**Economic and Social
Council**Distr.
GENERALECE/TRANS/WP.29/GRSG/2008/3
30 January 2008Original: ENGLISH
ENGLISH AND FRENCH ONLY**ECONOMIC COMMISSION FOR EUROPE**

Working Party on General Safety Provisions

REGULATION No. 46
(Devices for indirect vision)Proposed amendments to the RegulationSubmitted by the expert from the Netherlands^{*/}

Figure 1 Diagram of the blooming measurement set-up. 1: Black & white background. 2: Lamps to make the background evenly illuminated. 3: Mirror. 4: high intensity light. 5: Camera. 6: Monitor.

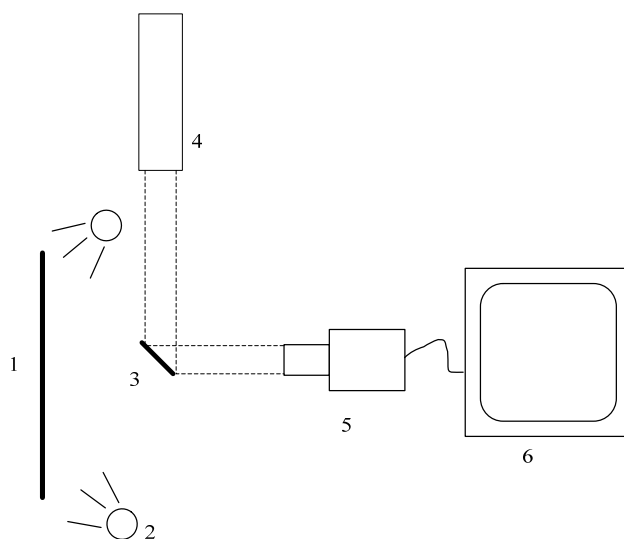
A high-intensity light (e.g., theatre spotlight) is reflected into the image using a small mirror (see Figure 1). The illuminance of the camera by the light reflected from the mirror shall be 40,000 lx. The light source is depicted in the centre of the camera: the light enters the camera from the normal direction. A high contrast black and white pattern (e.g. a checkerboard pattern) is illuminated by a set of lamps to create an even illumination of 3000 ($\pm 25\%$) lx.

The glare source should extend an angle (diameter) of 5° ($\pm 10\%$). A schematic drawing of the set-up is given in Figure 1.

The mirror shall be placed such that its image is positioned in the middle of the pattern. The luminance contrast between the white and black areas in the display image can be

measured. The saturated area is defined by the area in which the contrast of a high contrast test pattern falls below 0.2. The contrast (C) is defined by the difference in luminance between the bright (L_w) and dark (L_b ; black) and regions divided by the luminance of the bright (white) regions:

The saturated area shall not cover more than 10% of the display area.

In case the camera system shows dynamical changes in the blooming area during the test the maximum blooming area should fulfill the requirement."

This new annex contains a detailed measuring set-up for the test in which low sunlight falling on the camera is simulated.

Figure 2 Typical relationship between the size of the triangle and the fraction of correct responses.

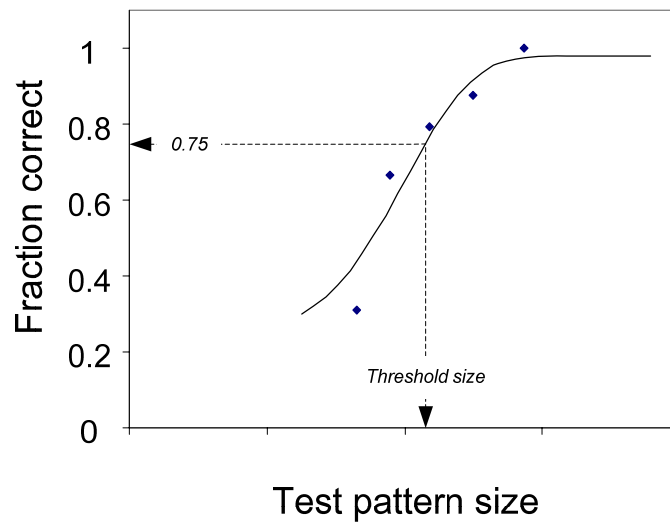
The TNO Landolt C test can be used to determine the smallest discernable detail of the camera-monitor system. However, for sensor systems it is more suitable to use the TOD (Triangle Orientation Discrimination) method which is similar to the Landolt C method, but involves equilateral triangular test patterns. The Triangle Orientation Discrimination method is described in detail by Bijl & Valeton (1999), who provide practical guidelines on how to perform a TOD measurement. In the method, triangular test patterns (see Figure 1) are viewed through the viewing system under test. Each triangle can have one out of four possible orientations (apex up, left, right or down) and the observer indicates/guesses for each triangle its orientation. When this procedure is repeated for many (randomly oriented) triangles of different sizes the fraction of correct responses can be plotted (see Figure 2), and increases with test pattern size. The threshold is defined as the point at which the fraction correct crosses the 0.75 level and can be obtained by fitting a smooth function through the data (see Bijl & Valeton, 1999). Critical perception is reached when the critical object diameter equals two times the width of the triangle at threshold size. The smallest discernable detail (ω_c) is equal to 0.25 times the width of the triangle at threshold size.

The procedure for calculating the maximum detection distance on the basis of video lines has been replaced by a new procedure based on ophthalmologis tests like Landolt-C or TOD (Triangle Orientation Discrimination).
